**TOWN OF MOUNTAIN VILLAGE
REGULAR DESIGN REVIEW BOARD MEETING AGENDA
THURSDAY MAY 1, 2025, 10:00 AM
MOUNTAIN VILLAGE TOWN HALL
455 MOUNTAIN VILLAGE BLVD, MOUNTAIN VILLAGE, COLORADO
TO BE HELD HYBRID THROUGH ZOOM:
<https://us06web.zoom.us/j/85097485733>
Meeting ID: 850 9748 5733**

Case Summary: Chris Hawkins of Alpine Planning is requesting Design Review Board (DRB) approval of an Initial Architectural and Site Review (IASR) for a new single-family detached condominium on Lot 161A-4 Unit 8, TBD Raccoon Lane. The lot is approximately 0.16 acres and is zoned multi-family. The proposed design consists of a two-story structure. The overall square footage of the home is approximately 7,543 gross square feet. Because of the home's location near the top of Coonskin Ridge, additional development regulations must be addressed in addition to the general Design Review Standards – specifically, CDC Section 17.5.16: Ridgeline Lots. The applicant has provided all the required materials for the IASR for the proposed home.

1 LOWER LEVEL EXTERIOR LIGHTING PLAN - AREA A
LX1A SCALE: 1/4" = 1'-0"

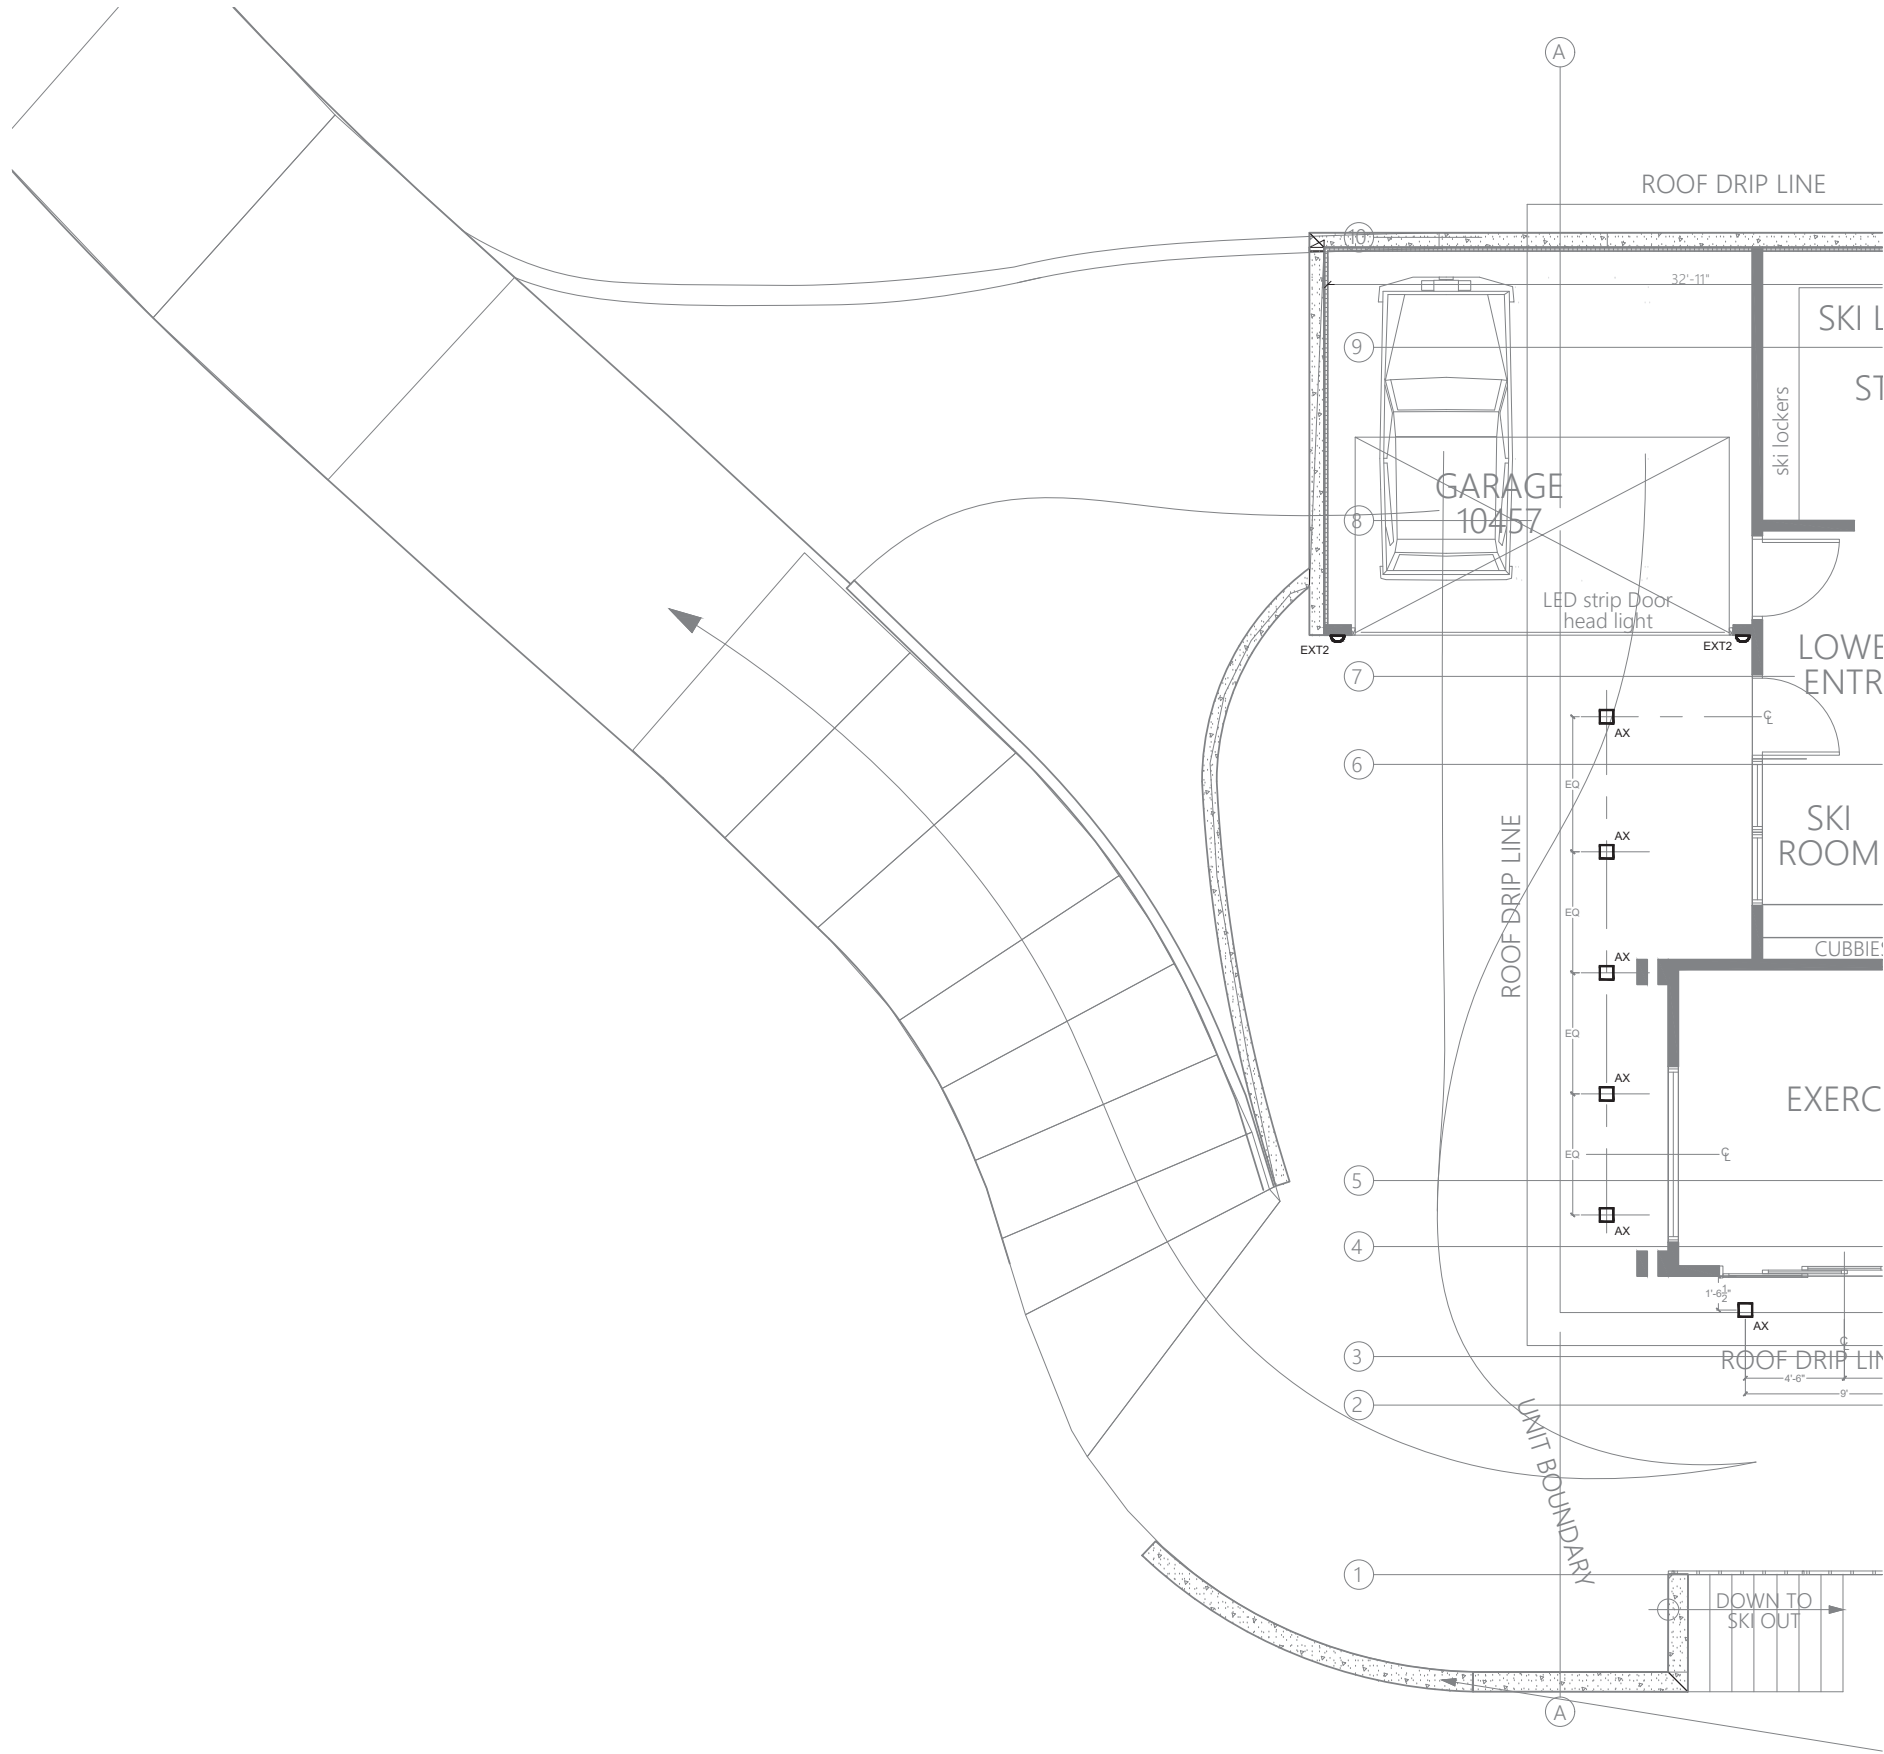
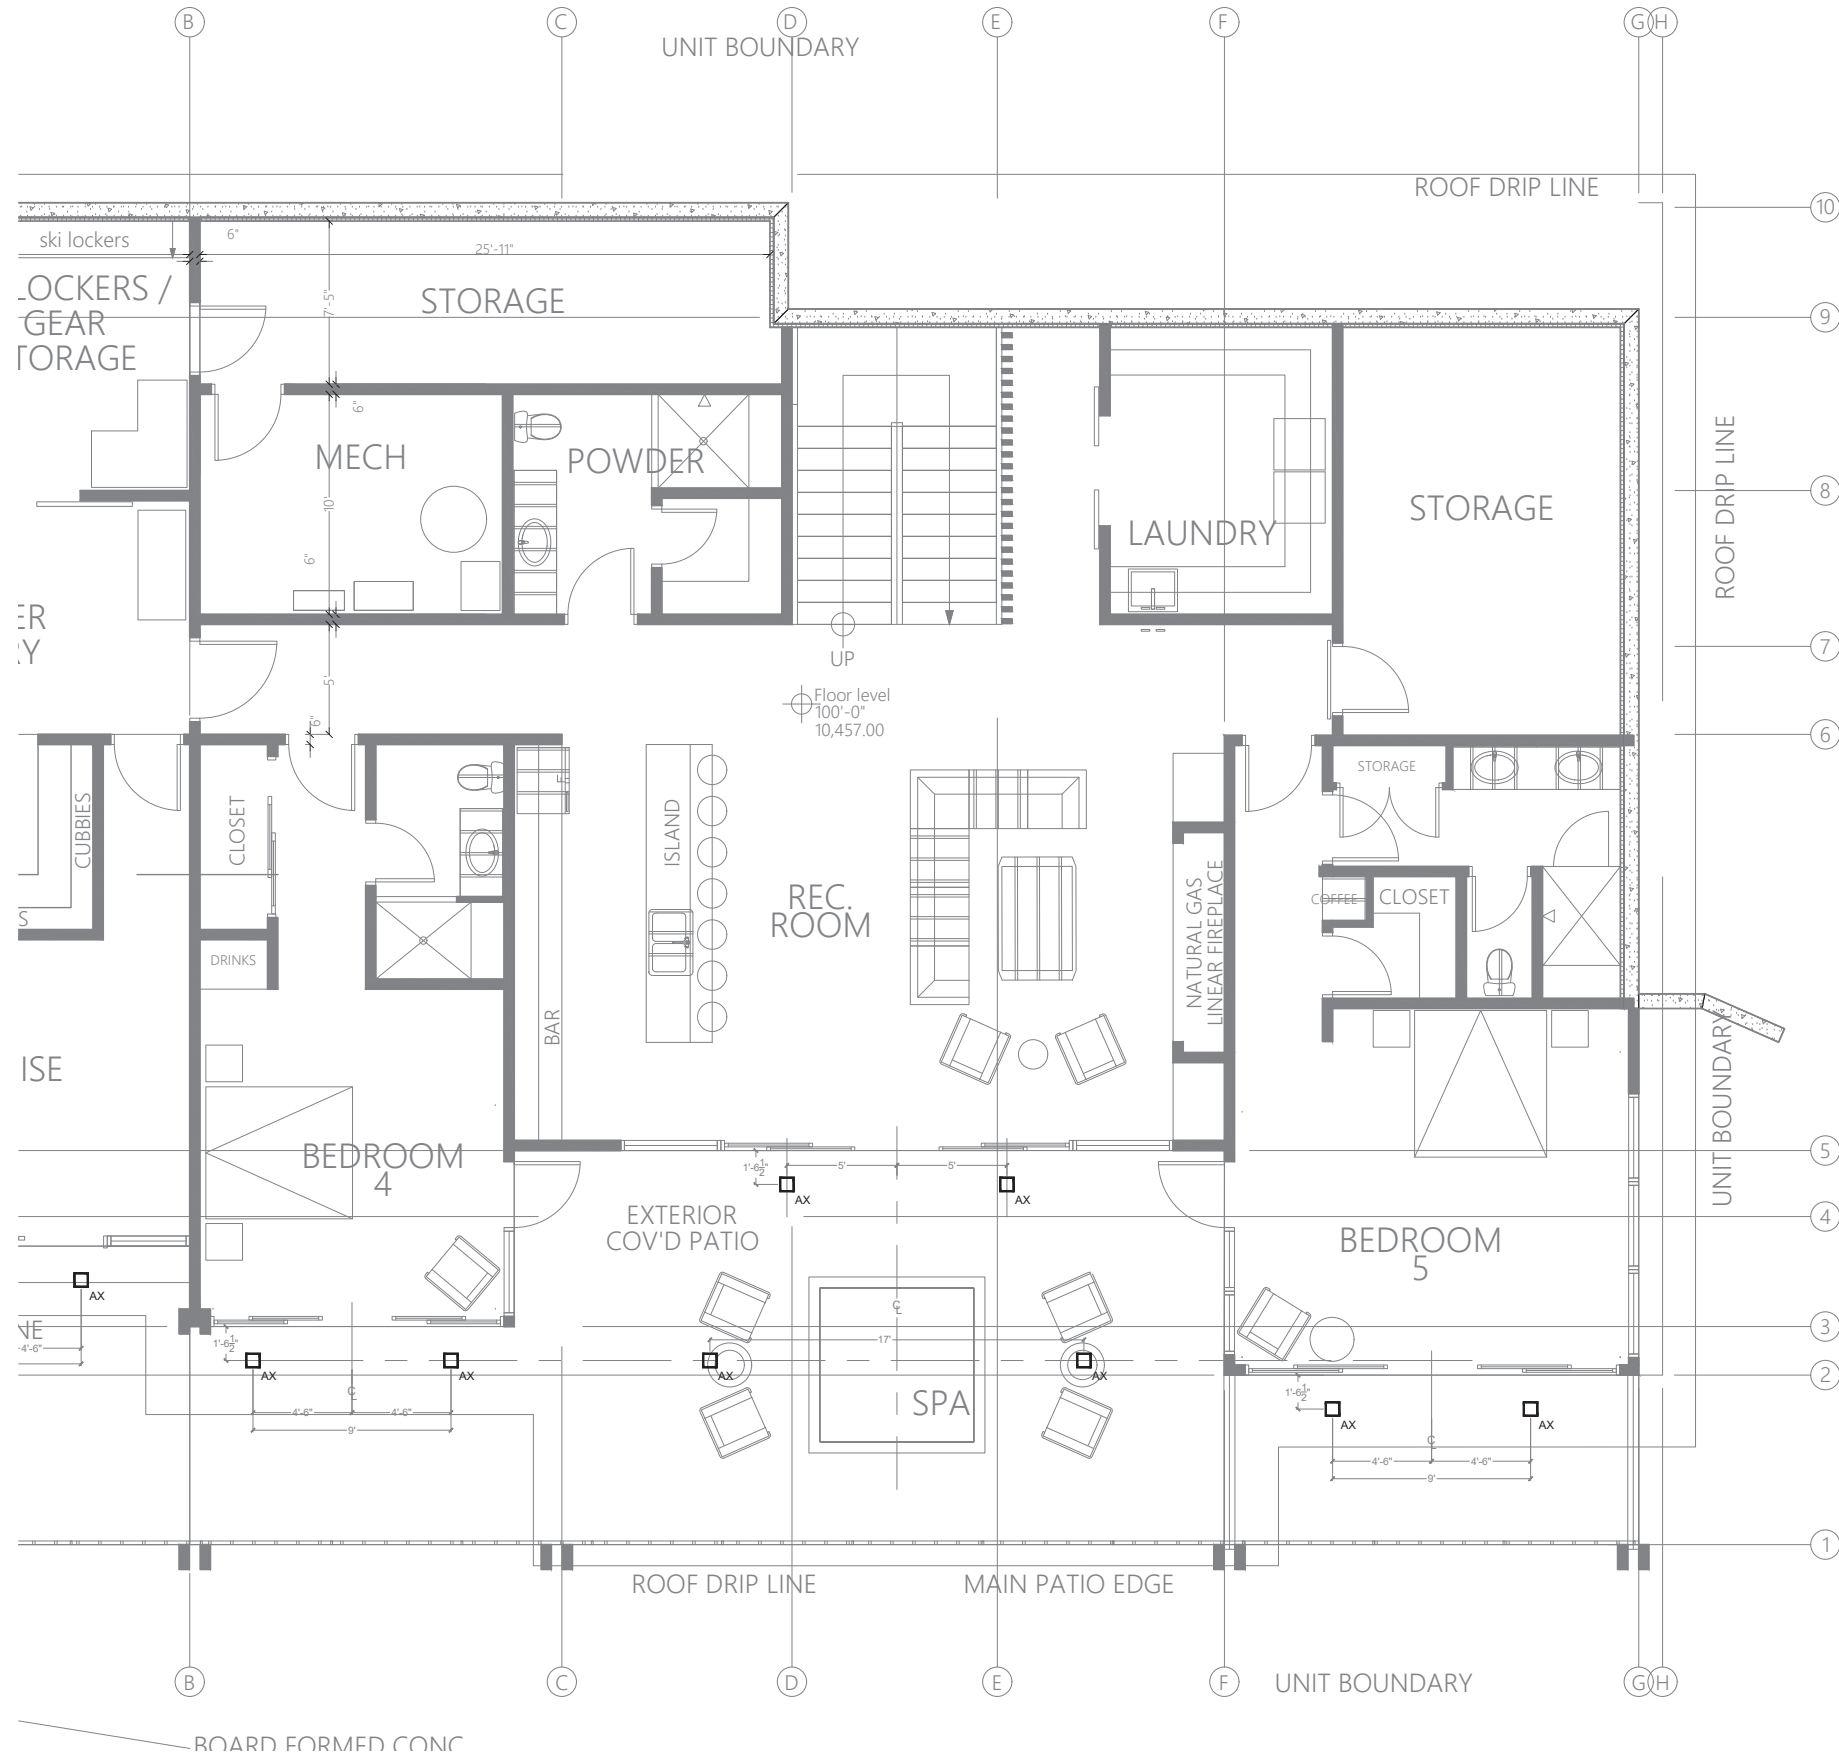
Staff: A lighting plan was provided on Sheets LX1-LX2B. The plan includes a recessed can, step light, two wall sconces, and a 3" bollard. Fixture DX is 170 lumens and proposed as an in-slab up-light on the columns in the entry walkway. Up-lighting is prohibited per the CDC. In its proposed installation it would likely also be considered architectural lighting, which is also prohibited without a design variation. The fixture as proposed requires a design variation. The DRB should discuss if a design variation should be granted for this. The other fixtures proposed are dark sky and CDC compliant. Staff finds that there is a reasonable amount of fixtures proposed. A photometric study is required for final review.

Staff: The applicant has proposed several fixtures including up lights on northeast elevation in the entry walkway. The lights will likely be shielded by the wood pillars; however, the applicant should provide a photometric plan to demonstrate this. A photometric study is needed to determine if light fixtures on the northeast elevation should be reduced.
